5260 UNIVERSITY WAY NE SEATTLE WA 98105 **RECOMMENDATION MEETING** NORTHEAST DESIGN REVIEW BOARD December 15, 2014 DPD# 3015604 OWNER **APPLICANT** RONG YING WU STUDIO19 ARCHITECTS PERFECT WEALTH, LLC 207 1/2 1ST AVE S. SUITE 300 1905 108TH AVE NE SEATTLE, WA 98104 BELLEVUE, WA 98004 PHONE: 206-466-1225 PHONE: 408-216-3791 studio19 architects lhammersmith@studio19architects.com

EDG RESPONSE - MASSING & ARCHITECTURAL CONCEPT

EDG RESPONSE - STREET LEVEL DEVELOPMENT

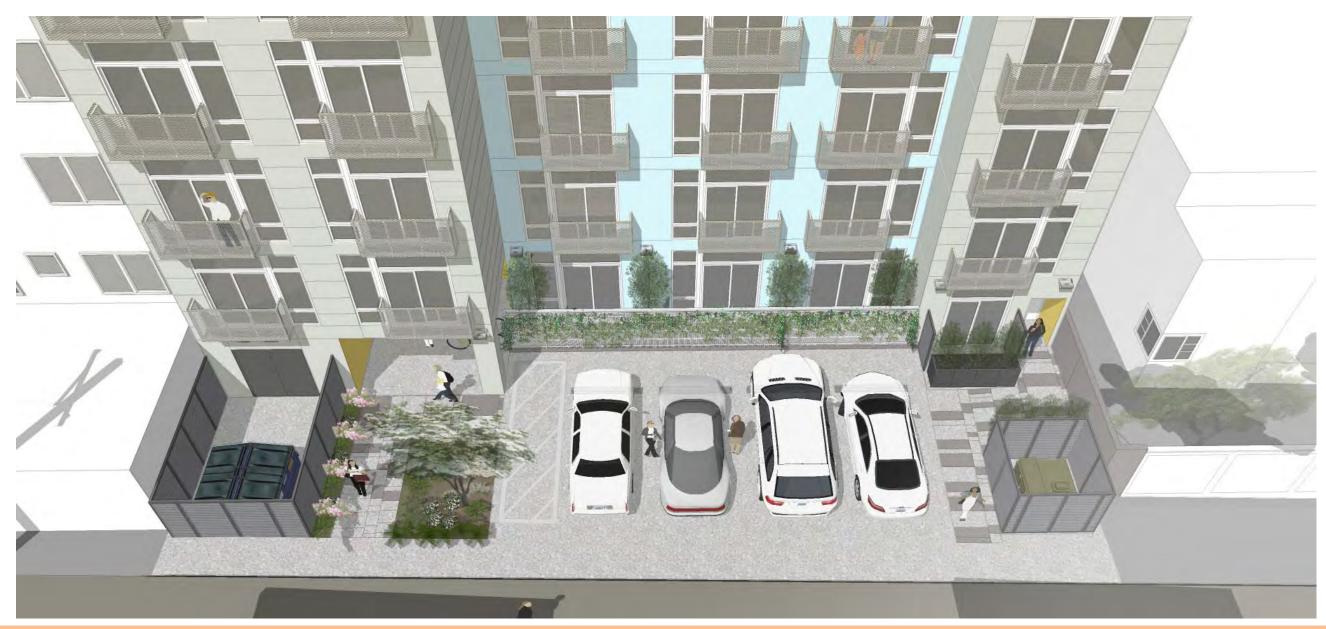
Street Leve	reet Level Design			
ITEMS	TITLE	EDG COMMENTS	RESPONSE	
PL3	STREET LEVEL INTERACTION	The retail street frontage should be continuous in order to allow more flexible	The residential entry occurs at an end bay which allows for continuous storefront and flexible	
DC1-A	PROJECT USES AND ACTIVITIES - ARRANGEMENT	division of retail spaces over time.	use of the retail space. The residential entry is located at the south end of the building where	
	OF INTERIOR USES		the blank edge of the adjacent building's north party wall helps define the space creating a	
CS2-B	URBAN PATTERN AND FORM - ADJACENT SITES,	The Board recommended that the residential entry should be located at either	welcoming entry sequence from the sidewalk. The entry bay is differentiated by a change in	
	STREETS, AND OPEN SPACES	the north or south end of the street frontage. The off-set entry offers an	materials and colors, though still visually cohesive with the rest of the building by using similar

CS2-C	RELATIONSHIP TO THE BLOCK	opportuniy for modulation at the upper levels. The entry should be designed	architectural elements. Bold use of color on the residential entry canopy, as well as the entry	
PL3-A	STREET LEVEL INTERACTION - ENTRIES	to be sufficiently sized and welcoming to residents.	door at street level is carried throughout the 6 floors above.	
PL3-B	RESIDENTIAL EDGES

EDG RESPONSE - ALLEY LEVEL DEVELOPMENT

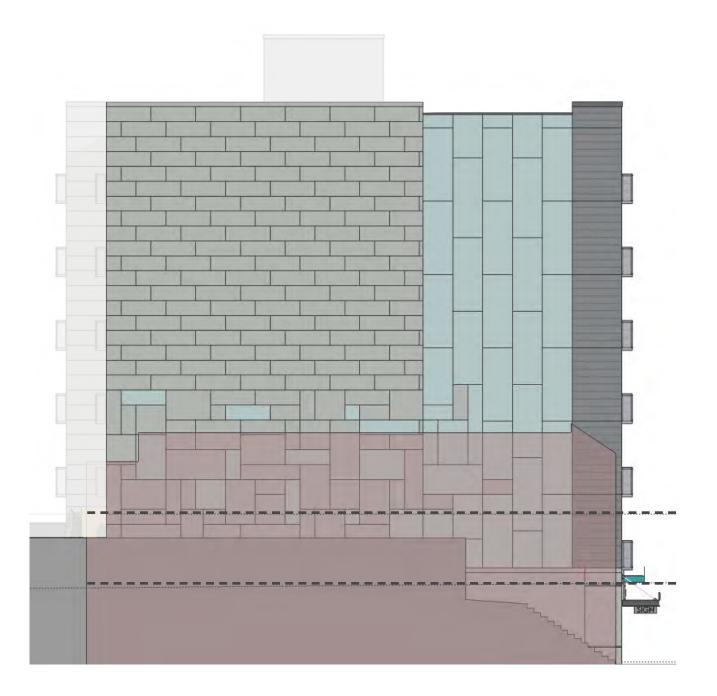
Alley Leve	ey Level Development			
ITEMS	TITLE	EDG COMMENTS	RESPONSE	
CS2-D	URBAN PATTERN AND FORM - HEIGHT, BULK, AND SCALE	The Board recommended that the alley façade should instead reflect Massing Option A or a similar plan that provides usable building area and outside space.	The current design reflects Massing Option A. This proposed design includes four surface residential parking stalls which are accessed directly off the alley. Landscaping elements include	
PL3-A	STREET LEVEL INTERACTION - ENTRIES		a 6'-6" tall green screen between the parking and adjacent units, private patios for grade level	
PL3-B	RESIDENTIAL EDGES		units and planting areas that define the residential entry.	
DC4-D	TREES, LANDSCAPE AND HARDSCAPE MATERIALS	The Board noted that Massing Option A also has the opportunity for landscaping in the soil rather than on a structure, making it possible to plant larger trees and more mature landscaping. The proposed development should be designed to achieve this goal.	The alley is in keeping with more typical urban alley characteristics where services are located, residential entries are secondary to those on the street front and vehicles are parked. The utility services and equipment located on the alley are enclosed with corrugated metal siding that ties back to the metal siding on the street facade.

PL3-B	RESIDENTIAL EDGES	The alley open spaces should be designed for safety, including lighting and eyes on the 'street' or alley in this case.	The large glazed area at every unit provides "eyes on the alley", increasing the level of security.
